SI2019-009

Regarding 8DB 355 013-331 (T1699) → 8DB 355 025-331 (T2633) / 8DB 355 025-341 (T2634)

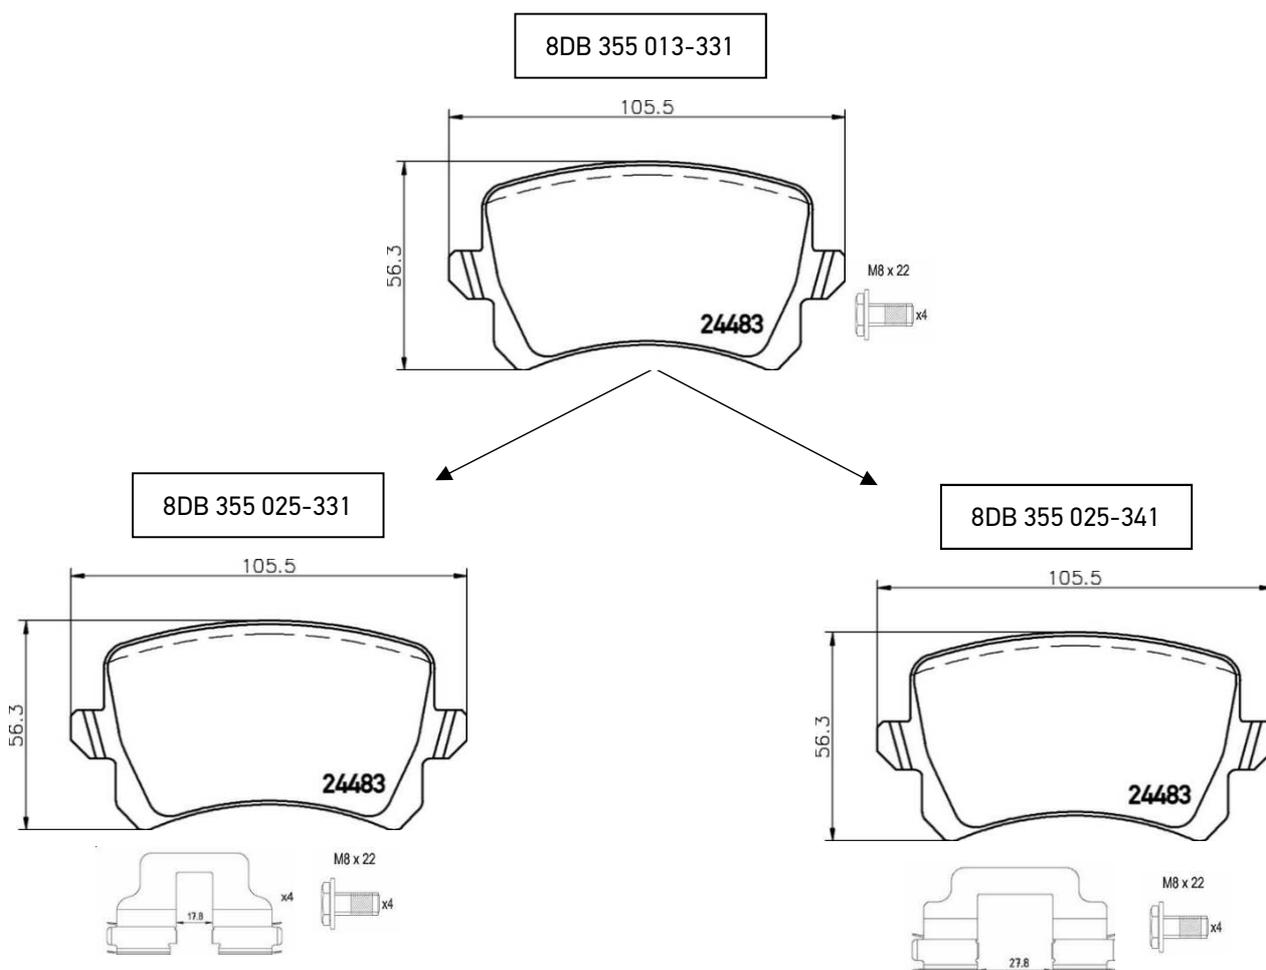
To optimize the product specification for the brake pad set 8DB 355 013-331 and in order to underline and follow the OE approach Hella Pagid decided to add accessory kits to the set.

Depending on the vehicle specification two different accessory kits are needed. In order to meet those requirements, the 8DB 355 013-331 has been split into two different part numbers, so that customers can easily choose the right part number for their needs.

8DB 355 013-331 will be replaced by 8DB 355 025-331 (incl. sliding shims with 17.8 mm gap) and 8DB 355 025-341 (incl. sliding shims with about 27.8 mm gap). Please see the differences in the pictures below.
